Access Compliance Report

Public Rights-of-Way

(Pedestrian Signals)

Intersection ID: N/A	Main Street:	Cross Street: N/A	Location: N/A
ADA ID: 5325405CFF70	Signal Type: Two Push Buttons-APS	Overall Compliance: No	Severity Score: BTN 1:N/A BTN 2: N/A No BTN: N/A
Codes/Mitigation Info/Possible Solution		Field Measurements/Component Compliance

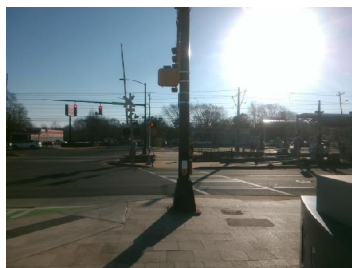
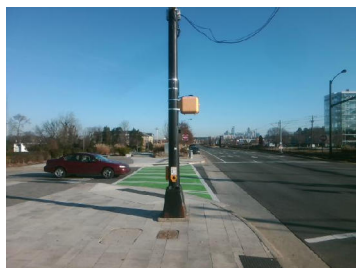
Possible Solutions: Replace Signal Push Button With APS Button on New Post.
Remove & Relocate Sign. Remove & Replace Replace APS Button With New APS Button.
Remove and Replace Clear Space.

PROW/ADA: TMUTCD 4e.08, R404.2, R406.2, , R209.1, R404.3
